HUSQVARNA TECHNICAL BULLETIN HTB2401 - USA

START/STOP SWITCH REPLACEMENT

2024 FE 350s

2024 FE 501s

Fig. 1 – New Start/Stop Switch #A46011074000

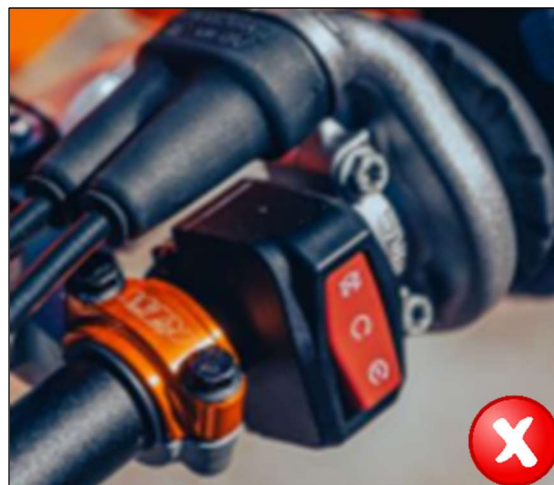
On motorcycles with the currently installed start/stop switch (p.n. A49011074000), there may be problems with the motorcycle starting automatically.

For this reason, the start/stop switch (p.n. A49011074000) installed on affected motorcycles must be replaced with a different version (p.n. A46011074000).

1. Remove the headlight mask, throttle housing and grip.
2. Replace the original start/stop switch with the new replacement start/stop switch using part number **A46011074000**.
3. Reinstall the throttle housing (torque 5 Nm), grip and headlight mask.
4. Destroy the original start/stop switch by cutting the wires and take a photo of it so you can attach it to the TI warranty claim (Fig. 3).
5. Submit the TI warranty claim with the photo of the destroyed start/stop switch.
